RECORD OF DECISION AMENDMENT

ANACONDA REGIONAL WATER, WASTE, AND SOILS OPERABLE UNIT

*Anaconda Smelter National Priorities List Site
Anaconda – Deer Lodge County, Montana*

September 2011

**Figure 7-1. Old Works/Stucky Ridge Subarea
Significant Changes**

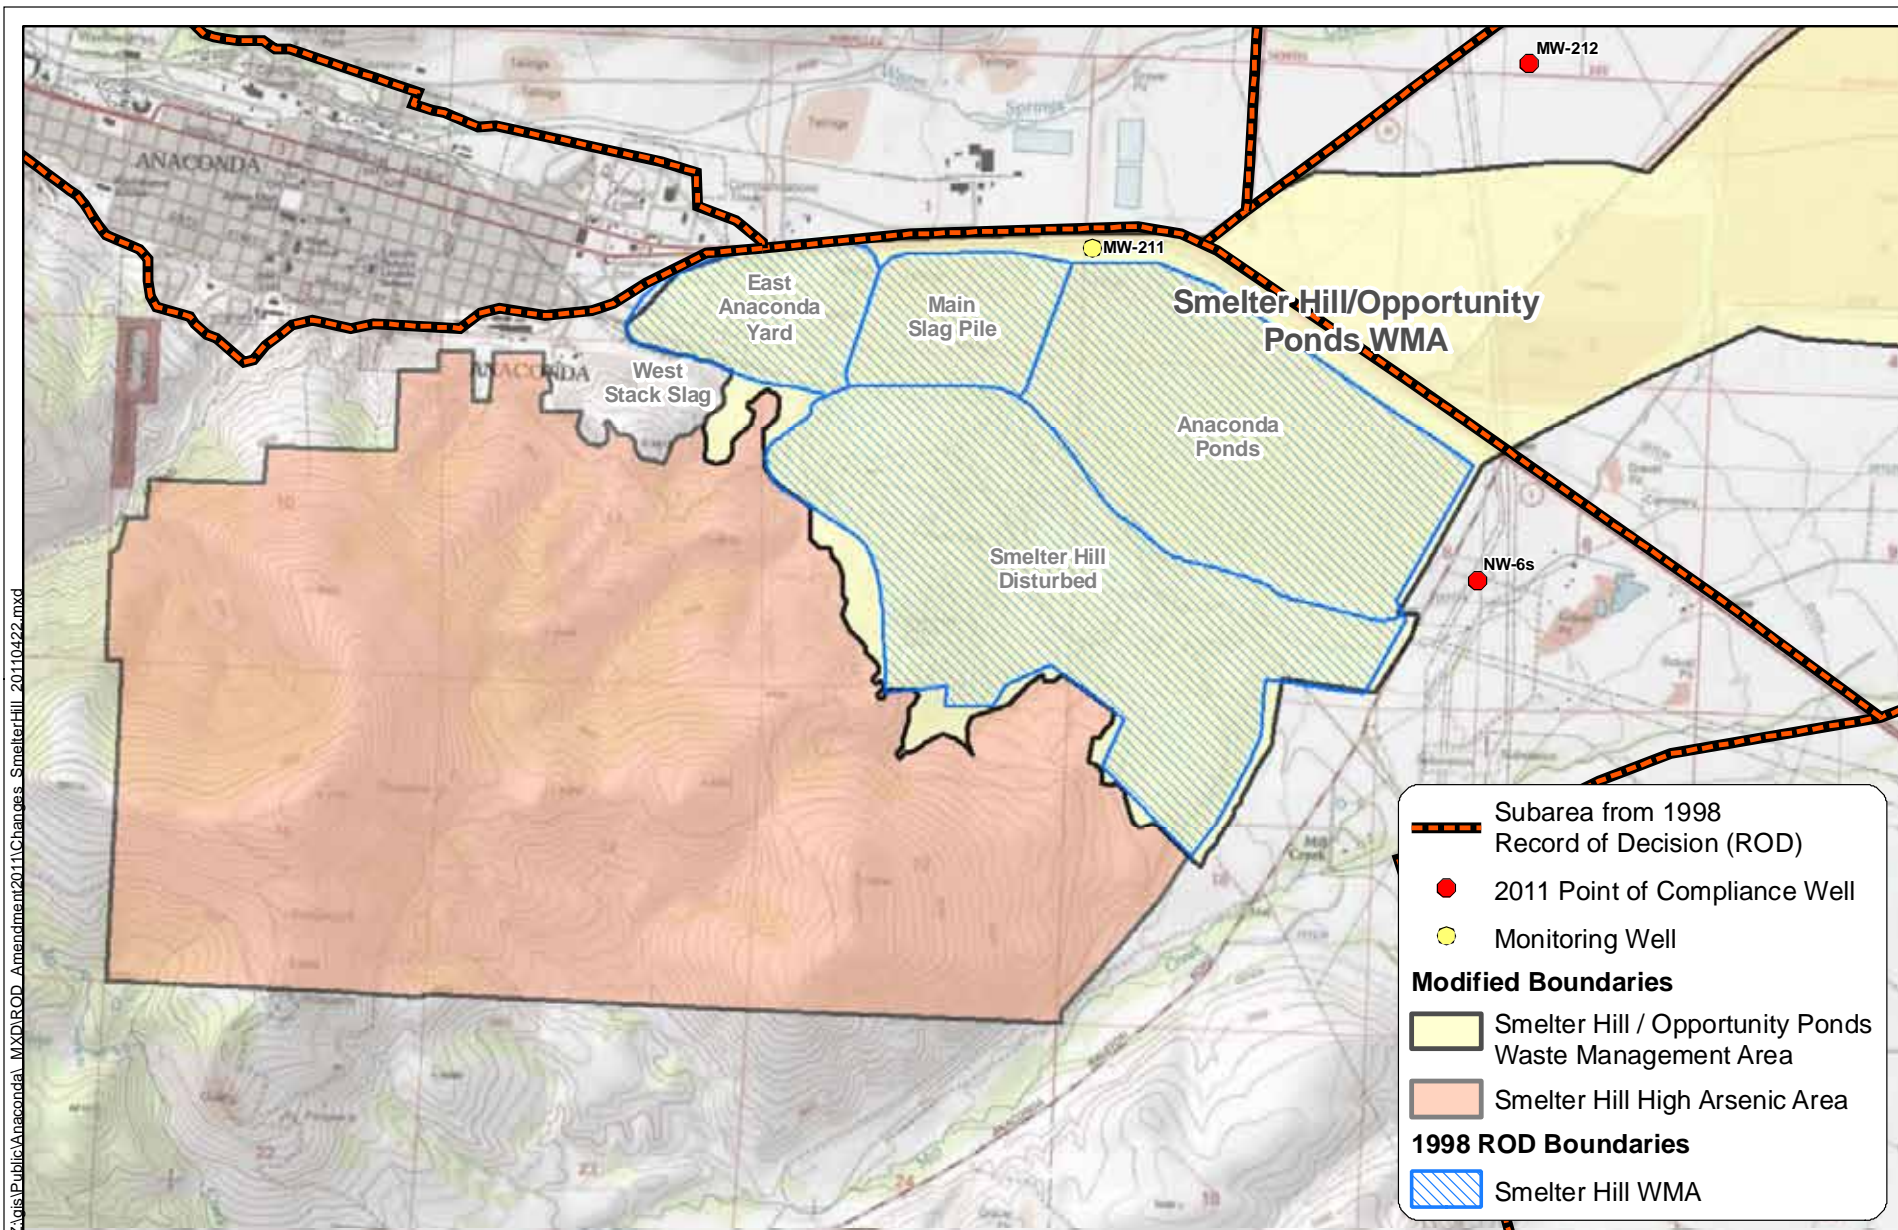
Expansion of Old Works WMA boundary requires moving the ground water POCs. Old Works ground water POCs are shown on Figure 7-1. The new POC consist of monitoring wells MW-207, MW-252, MW-251, and MW-255. The *RDU 13 Old Works Final Design Report* (Atlantic Richfield 2010) also includes a monitoring plan to monitor ground water at the POCs and within the WMA. Ground water will also be monitored during high ground water table conditions during spring runoff occur, which may mobilize precipitated contaminants in the vadose zone between low and high water table events.

Figure 9-1. Bedrock Aquifer/Spring-Fed Tributaries Fundamental Changes

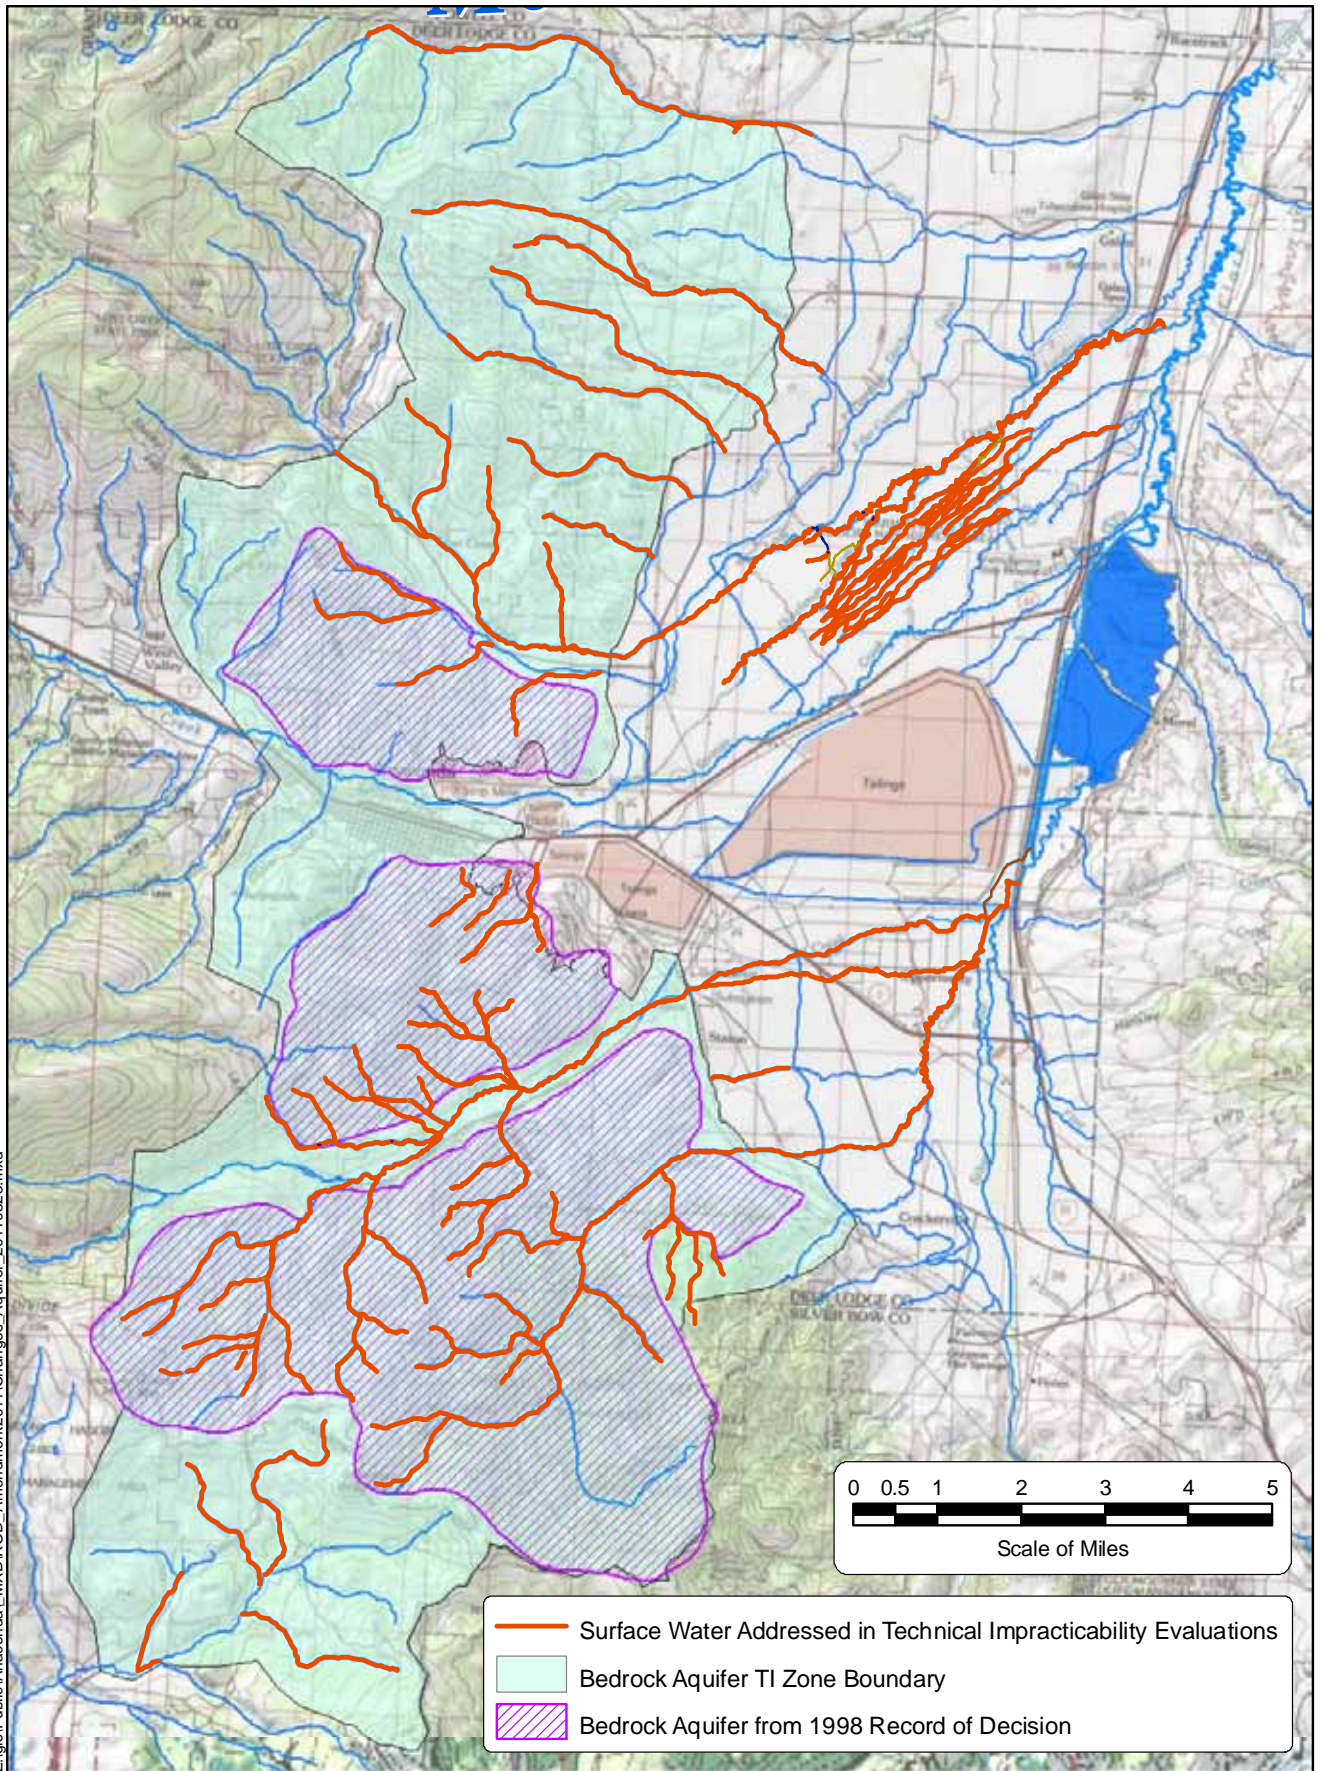
Based on the additional information presented in the second addendum to the bedrock TI evaluation, the TI zone boundaries are revised as shown in Figure 9-1. Areas where ground water in the bedrock aquifer exceeds the standard of 10 µg/L arsenic are delineated based on direct ground water sampling in wells and springs. While the previous bedrock TI Zone delineations relied on this direct sampling data, this addendum also incorporates surface water data collected from spring-fed tributaries as a surrogate for ground water data. Surface water data collected from tributaries is indicative of ground water quality (due to discharge from springs) and ground water contamination is inferred based on surface water quality. Ground water in the bedrock aquifer beneath alluvium in the Warm Springs Creek valley is known to be contaminated and it is assumed that the bedrock aquifer beneath other alluvial valleys is also contaminated.

The Spring-Fed Tributaries TI Analysis focuses on the spring-fed tributaries to mainstem named streams because the available data are mostly limited to these water bodies. Figure 9-1 shows the surface waters addressed in the TI Analyses. The results of the analysis are extended to include all state surface water within the boundaries of the TI Zone shown in Figure 9-1 because the loading sources are continuous and the potential exists for arsenic concentrations to occasionally exceed 10 µg/L in surface water throughout the TI Zone.
